REMARKS

By this Response, Applicants have amended the specification and claims 18-20, 30 and 33-34. Claims 31 and 32 have been cancelled without prejudice or disclaimer of the subject matter recited therein. Applicants have also amended FIGs. 1-7 to remove "related" from the legend and add "prior", as indicated in red in the annotated sheets showing changes. Claims 18-20, 30 and 33-34 are currently pending. No new matter has been added. Reconsideration and withdrawal of the objections and rejections in view of the above amendments and the following remarks are respectfully requested.

FIG. 1

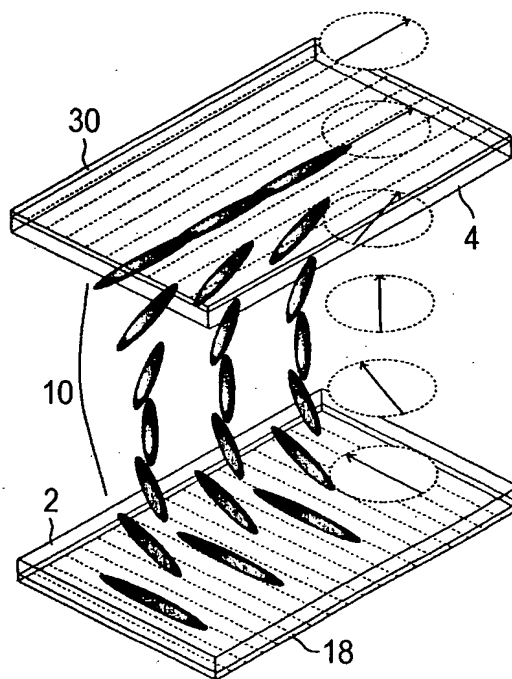
In the Office Action, FIGs. 1-7 have been objected to. Applicants have amended FIGs. 1-7 as indicated in the attached annotated sheets showing changes, and submit corresponding replacement sheets to reflect the changes made. Accordingly, the objection is overcome.

*prior
(related art)*
